Exhibit C: Terrace Park

The Terrace: Perspective View

U.S. COMMISSION OF FINE ARTS APPROVED CONCEPT UPDATE | OCTOBER 19, 2017

DISTRICT
WHARF

Previous Illustrative Site Plan, July 23, 2017

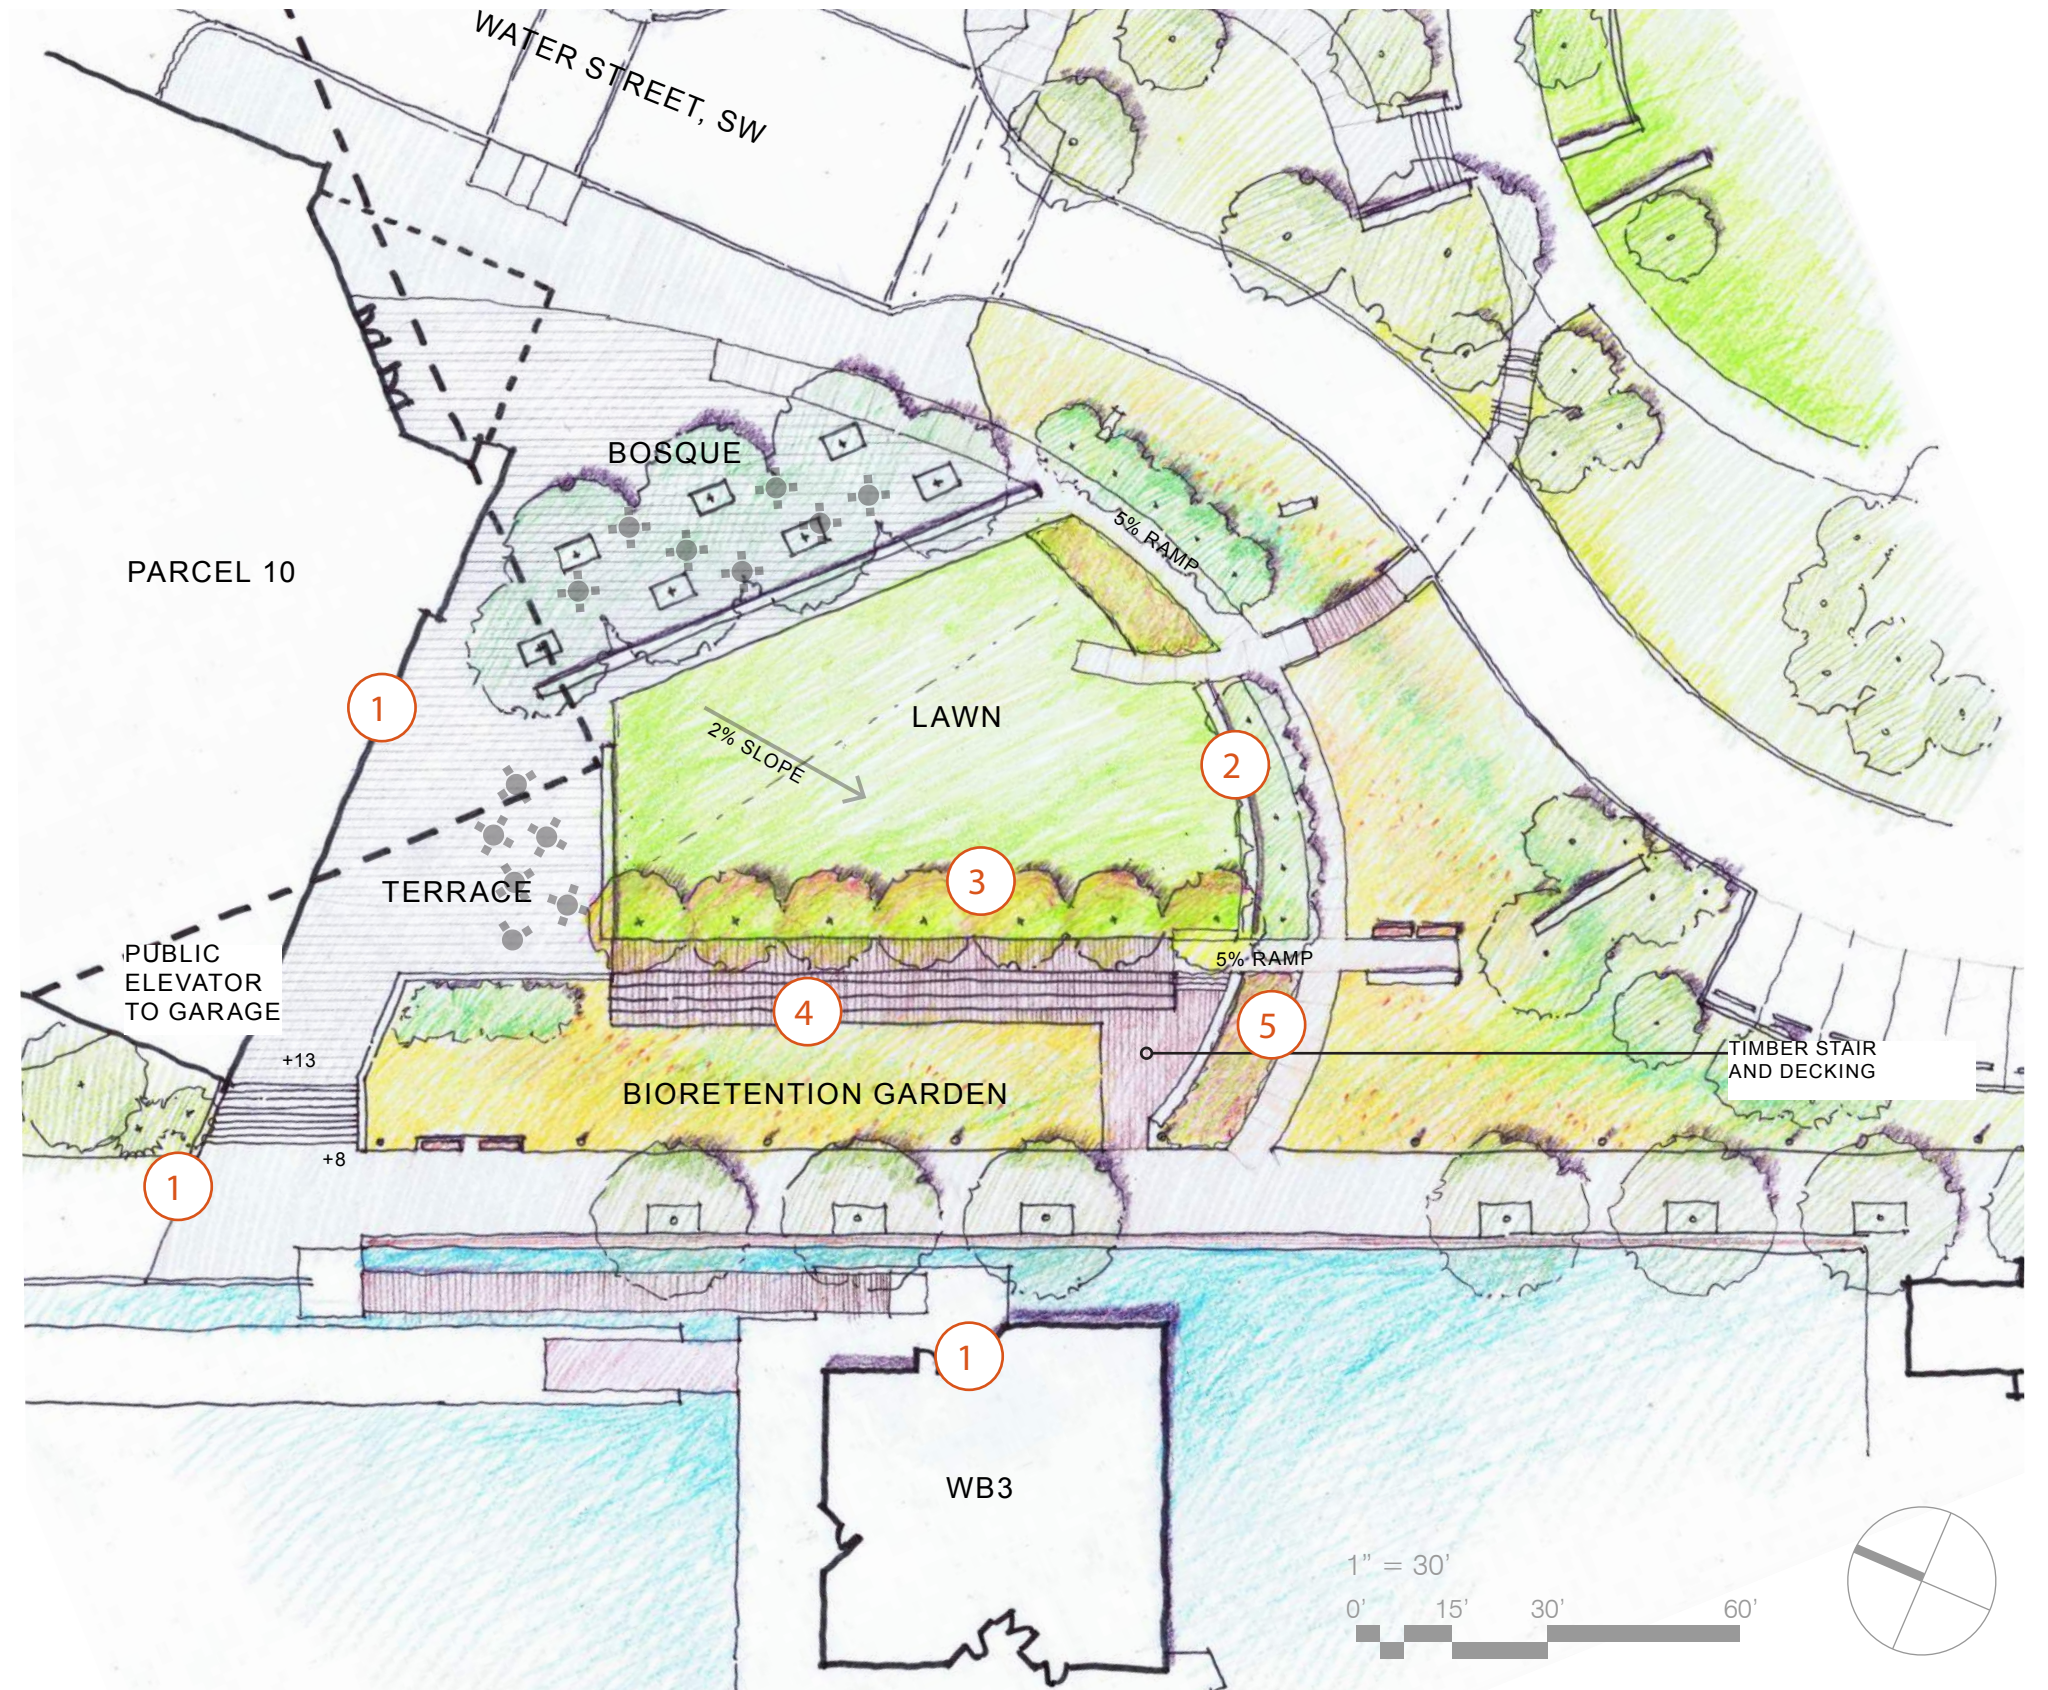
1. Design should be more strongly influenced by the adjacent buildings and open space
2. Question selection and placement of cherry and serviceberry trees. Request larger shade trees.
3. Utilize a denser planting of shade trees and plantings around central lawn and bioretention garden to achieve the intended framing of an outdoor room
4. Suggest that stepped seating not be rectilinear, but rather jut out into the landscape.
5. Suggest more consistent "wilder palette" along arc path to create more singular more expressive gesture.

Previous Illustrative Site Plan, July 23, 2017

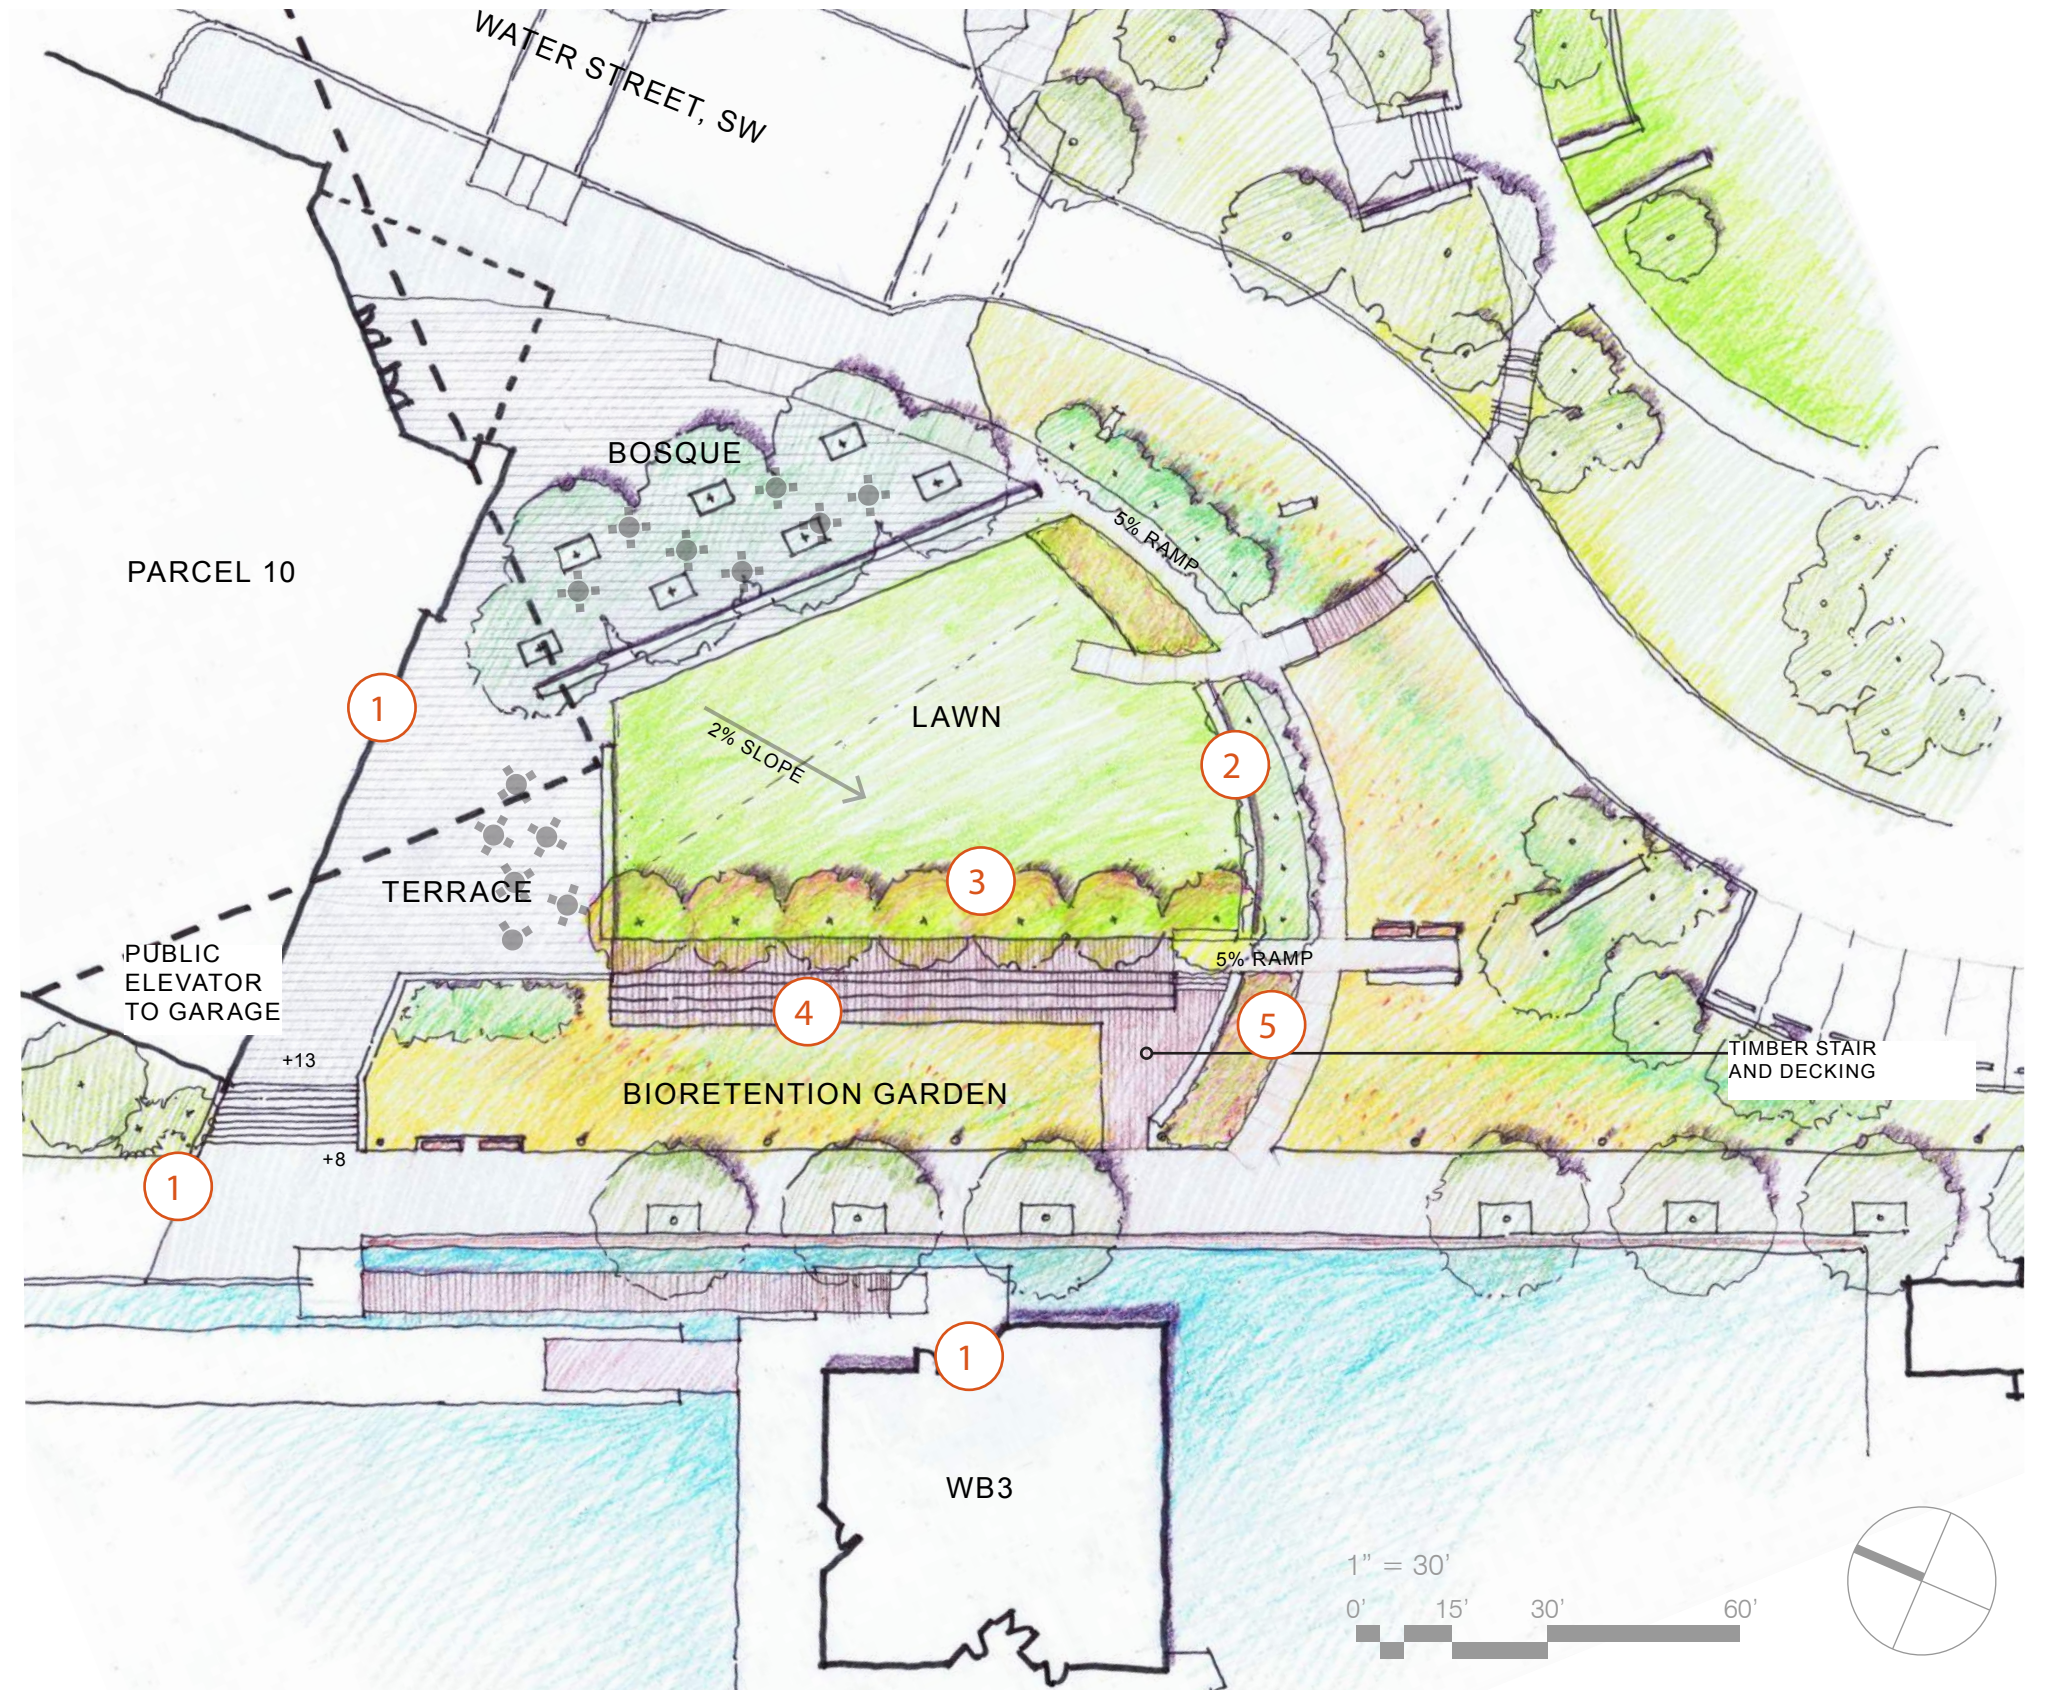
1. Design should be more strongly influenced by the adjacent buildings and open space
2. Question selection and placement of cherry and serviceberry trees. Request larger shade trees.
3. Utilize a denser planting of shade trees and plantings around central lawn and bioretention garden to achieve the intended framing of an outdoor room
4. Suggest that stepped seating not be rectilinear, but rather jut out into the landscape.
5. Suggest more consistent “wilder palette” along arc path to create more singular more expressive gesture.

1. Adjusted site wall to curved form, opening views. Revised site wall geometries and planting layout respond better to Parcel 10, M St Landing and WB3 access.
2. Revised tree selections and layout.
3. Larger trees now frame the western edge along curved wall to frame the outdoor room and provide afternoon/evening shade
4. Design of timber stair and decking frames views across Washington Channel and to the Potomac.
5. Planting palette is unified along the arc path on both sides, bioretention plantings will be used.
